UNITED STATES PATENT AND TRADEMARK OFFICE

APPLICATION NO.	FILING DATE	FIRST NAMED INVENTOR	ATTORNEY DOCKET NO.	CONFIRMATION NO.
10/529,573	03/29/2005	Robert David Black	ROCKCO P69AUS	9147
20210 7590 11/18/2008 DAVIS BUJOLD & Daniels, P.L.L.C. 112 PLEASANT STREET			EXAMINER	
			HUAZ, OMAR F	
CONCORD, N	NH 03301		ART UNIT	PAPER NUMBER
			3633	
			MAIL DATE	DELIVERY MODE
			11/18/2008	PAPER

DETAILED ACTION

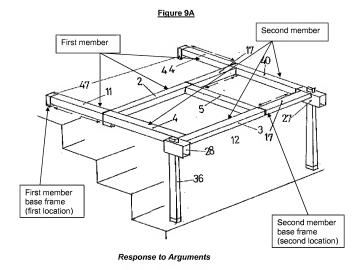
U-shaped first and second members (as illustrated, the support device has first and second U-shaped members; figure 9A below), each of the first and second members comprises a base frame defining one end of the open central region (as illustrated, each of the first and second members has a base frame which define one end of the open central region; figure 9A below), and a pair of spaced apart side arms (as illustrated, the first member has a pair of spaced apart support bars 11 and 44, and the second member has a pair of spaced apart support bars 4 and 40; figure 9A below) extending parallel to one another from opposite ends of the base frame (as illustrated, the support bars 11.44 and 4, 40 are parallel and on opposite sides of the base frame; figure 9A); the pair of side arms of the first member being telescopically received within the pair of side arms of the second member, to facilitate adjustment of a length of the open central region (structural bars contain a structural bar with a smaller cross section and slide in one another; page 2, lines 8-9 of translated document); and the telescopic adjustment of the pair of spaced apart side arms of one of the first and second members each having a clamp for temporary securing of the side arms of the first member to the side arms of the second member (the threaded rod of tightening bolt 10 locks the sliding structural bars in a chosen position in the fixed structural bars; page 5, lines 12-14 of translated document) at a pre-determined relationship and maintaining the desired spacing of the base frame of the first member from the base frame of the second member (it is construed that the extent of the telescoping bars can be predetermined and the spacing can be maintained):

the second member having at least one adjustable prop (legs 36; as illustrated by the directional arrows, legs 36 are adjustable; figure 10) which is attached adjacent the base frame of the second member (as illustrated, the leg 36 is attached to the support bars 4 and 40; figure 9A) for supporting the second member at a desired level (the height of each leg can be adjusted by a quick locking system; page 2, line 12);

the base frame of the first member being adapted for position at a first location (as illustrated, the first member base frame is positioned at a first location; figure 9A); and

the base frame of the second member being adapted for positioning at a second location, remote from the base frame of the first member but at substantially a same level as the base frame of the first member (as illustrated, the base frame of the second member is positioned at a second location, which is remote from the first location, yet on the same level of the first location; figure 9A) so as to position the support frame of the access unit in a substantially horizontal orientation (as illustrated, the support device is horizontal; figure 9A), and an opposite end of the at least one adjustable prop being adapted for location at the second location (as illustrated, the opposite end of the legs 36 is at the second location; figure 9A) with the second location the being offset from and being located vertically below the first location (as illustrated, the location at which the legs 36 engage the bottom stair is offset from and vertically below the first location; figure 9A).
